Intersection ID: 17776	Main Street: CHELSEA_DR	Cross Street: TRANQUIL_AV	Location:	SW
ADA ID: 783F239E7872	Ramp Type: PerpDiag	Initial Pass/Fail: Fail	Overall Compliance: No	Severity Score: 12.5

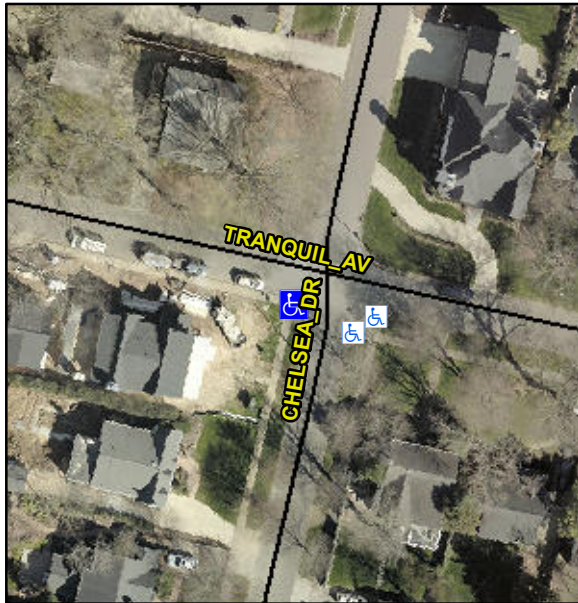
Not Found, R304.5.3

Compliance	Description	Data	Compliance	Description	Data
N/A	Ramp Length (in)	69.0	Yes	Ramp Slope (%)	8.3
Yes	Ramp Width (in)	48.0	No	Ramp XSlope (%)	6.0
N/A	Flare Type LT	N/A	N/A	Flare Type RT	N/A
N/A	Flare Slope LT (%)	N/A	N/A	Flare Slope RT (%)	N/A
N/A	Flare Traversable LT?	N/A	N/A	Flare Traversable RT?	N/A
N/A	Landing Length (in)	N/A	N/A	DWS Provided?	N/A
N/A	Landing Width (in)	N/A	N/A	DWS Contrast?	N/A
N/A	Landing Slope (%)	N/A	N/A	DWS Length (in)	N/A
N/A	Landing X Slope (%)	N/A	N/A	DWS Full Width?	N/A
N/A	Landing Curb? (Y/N)	N/A	N/A	DWS Offset (in)	N/A
N/A	Shared Landing?	N/A			
N/A	Gutter Ponding?	N/A	N/A	Gutter Slope (%)	N/A
N/A	Gutter Lip Ht (in)	N/A	N/A	Gutter X Slope (%)	N/A
N/A	Painted X Walk1?	No	N/A	Painted X Walk2?	No
	X Walk 1 Direction	To SE		X Walk 2 Direction	To NE
N/A	X Walk 1 Width (in)	N/A	N/A	X Walk 2 Width (in)	N/A
	X Walk 1 Slope (%)	0.2		X Walk 2 Slope (%)	2.6
	X Walk 1 X Slope (%)	4.0		X Walk 2 X Slope (%)	1.0

Remove & Replace Curb Ramp With Two New Directional Ramps or Equivalent.
